SMO UKI, RAIL INFRASTRUCTURE, NEW CHIPPENHAM FACILITY: TOWN AND COUNTRY PLANNING ACT 1990 (AS AMENDED), SECTION 96A – APPLICATION FOR NON-MATERIAL AMENDMENTS PURSUANT TO PLANNING PERMISSION REF: PL/2024/03204

On behalf of Siemens Mobility Limited (*“the Applicant”*), please find enclosed an application (*“the Application”*) for non-material amendments to planning permission Ref: PL/2024/03204 granted by Wiltshire Council on 25 October 2024.

Figure 1.0: Site Masterplan, as approved (Drawing Ref. SMC-AHR-EX-ZZ-D-L-008104_P19-B) (left), Site Masterplan, as proposed by this application (Drawing Ref. SMC-AHR-EX-ZZ-D-L-008104_P23) (right)

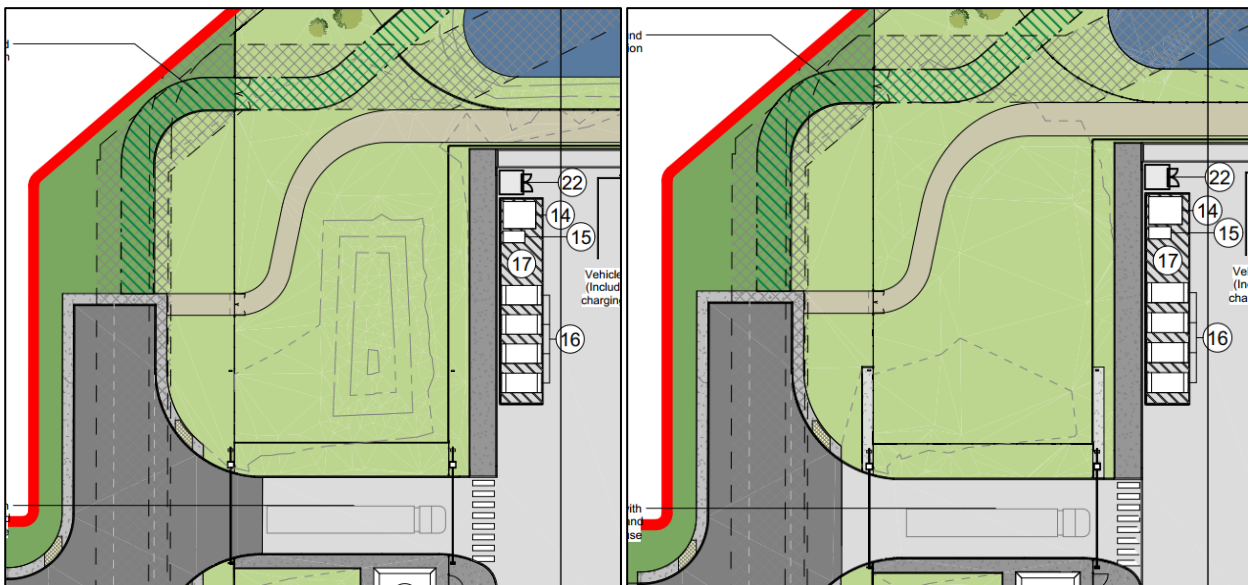
Removal of Bund

The proposed amendments seek to remove part of the bund located to the north of the building, to the east of the site access (see **Figure 1.0**). This bund was not included within the original planning permission and was introduced through non-material amendment application Ref. PL/2025/01624 to accommodate excess soil on-site.

During the earthworks stage of construction, it was determined that the bund is no longer required. This Application therefore proposes its removal, reverting to the arrangement consented by the original Planning Permission. The soft landscaping proposals for this part of the Site remain otherwise unchanged.
